APPROVED DRAWINGS HAVE BEEN RED LINED INDICATING A CHANGE TO MEET THE OBC. PLEASE REVIEW ALL PAGES TO ENSURE YOU ARE PROPERLY INFORMED OF CHANGES.

Tice River Homes  
Legacy

**TOWNSHIP OF NORTH DUMFRIES  
BUILDING DEPARTMENT**

These Plans have been examined for Compliance with the Ontario Building Code requirements. A Building Permit has been issued, subject to any changes noted, under the condition that the building will be constructed in accordance with the code.

**A6**

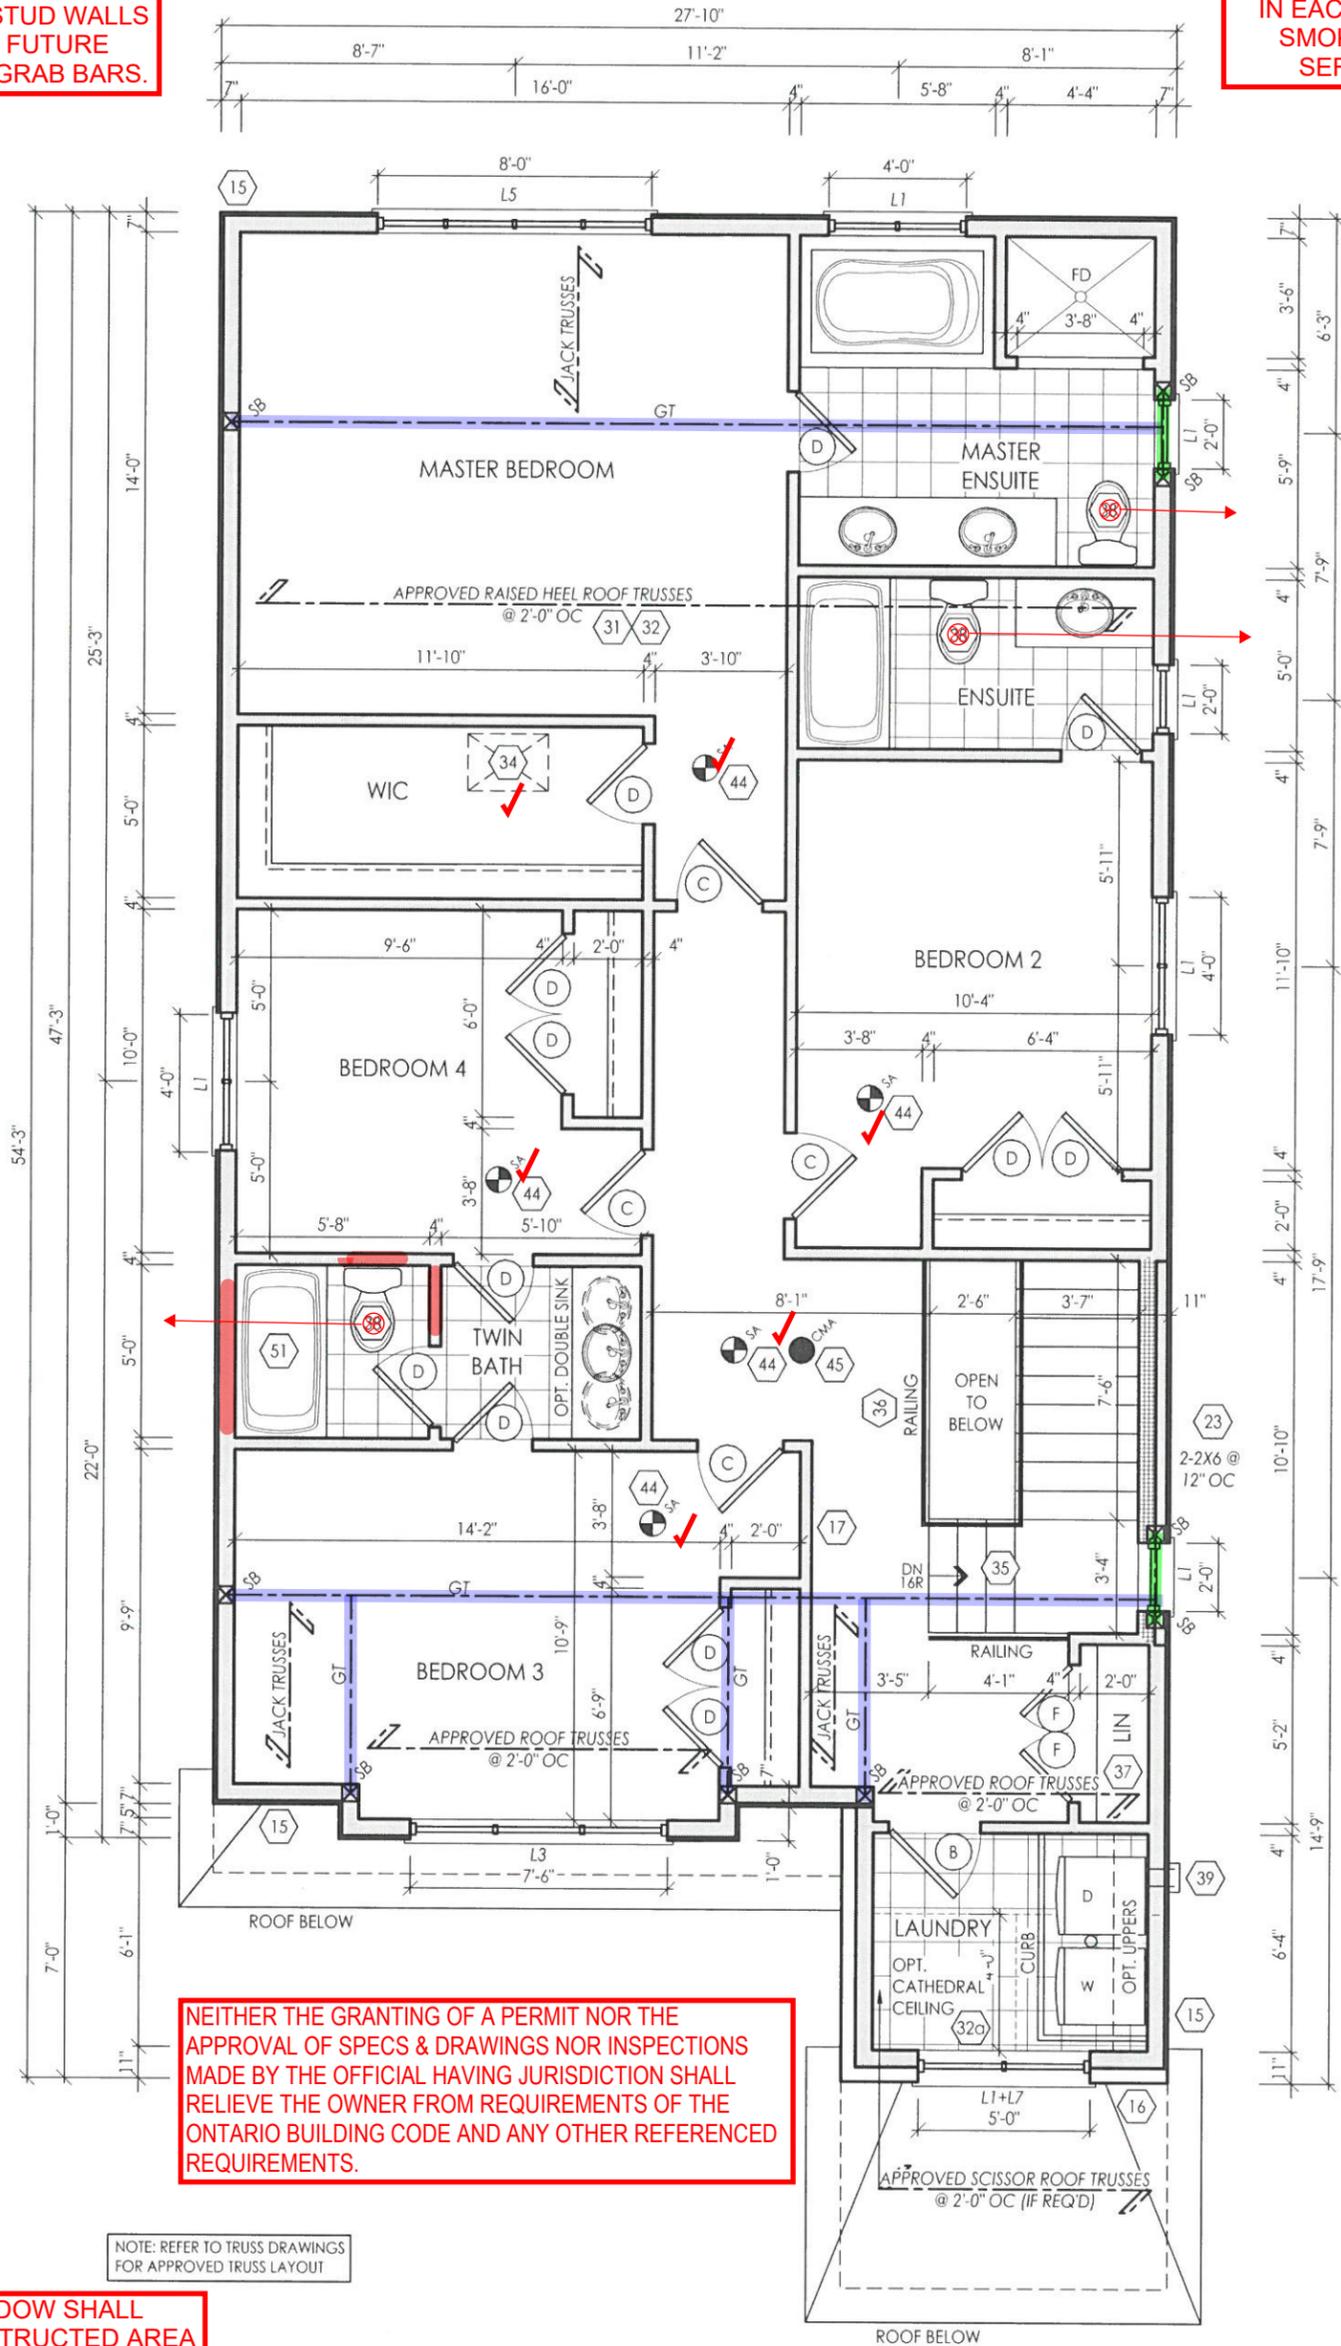
**REINFORCEMENT REQUIRED IN MAIN BATHROOM STUD WALLS TO PERMIT THE FUTURE INSTALLATION OF GRAB BARS.**

**SMOKE ALARMS WITH VISUAL ALARM ARE REQUIRED ON EACH FLOOR AND IN EACH BEDROOM INCLUDING A SMOKE/CO IN THE HALL THAT SERVICES THE BEDROOM.**

**AT LEAST 1 WINDOW SHALL PROVIDE AN UNOBSTRUCTED AREA OF 22" X 39" W/ A SILL HEIGHT MAX. 3'-3" ABOVE FINISHED FLOOR & 23'-0" ABOVE GRADE**

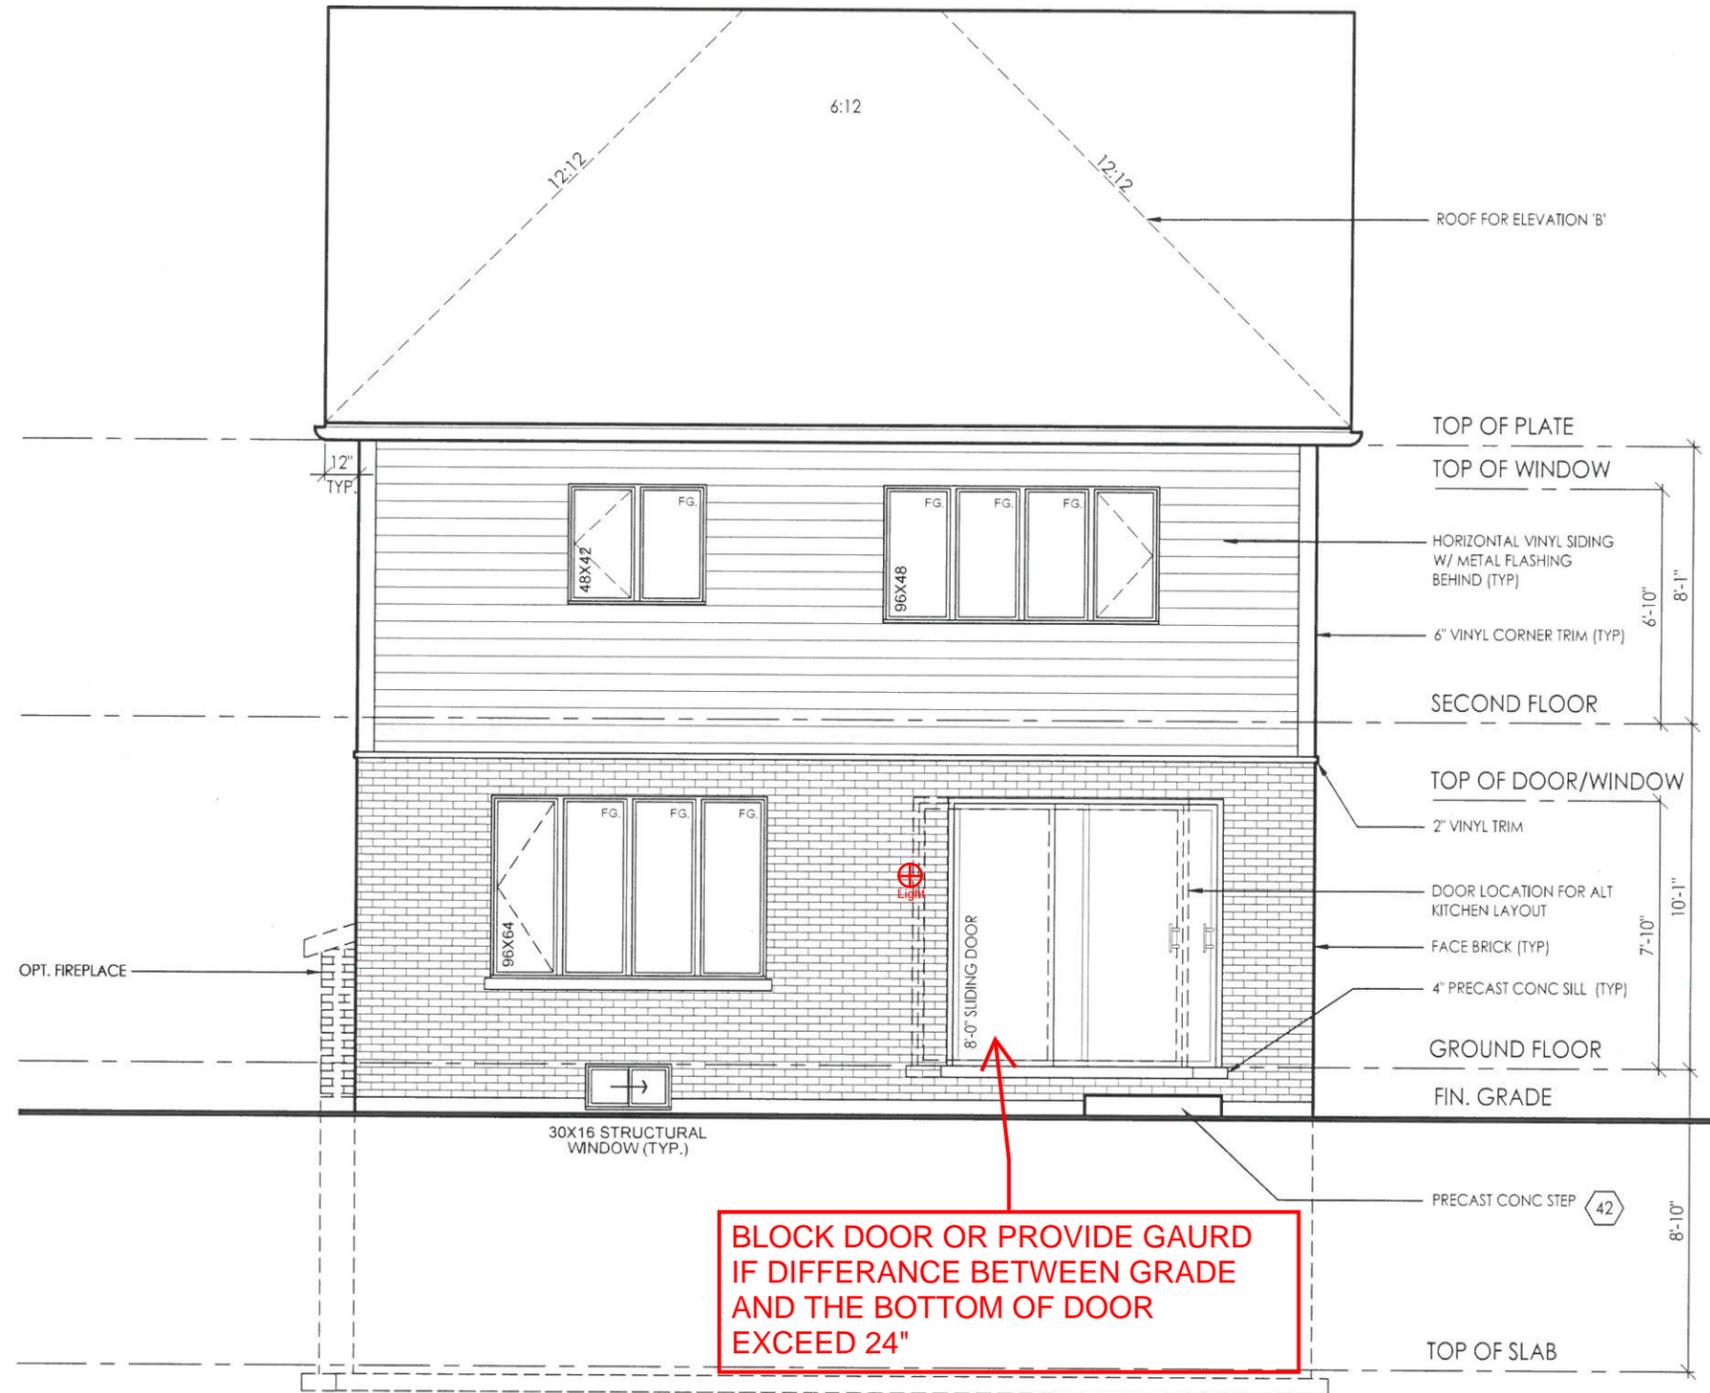
**BLOCK DOOR OR PROVIDE GAURD IF DIFFERANCE BETWEEN GRADE AND THE BOTTOM OF DOOR EXCEED 24"**
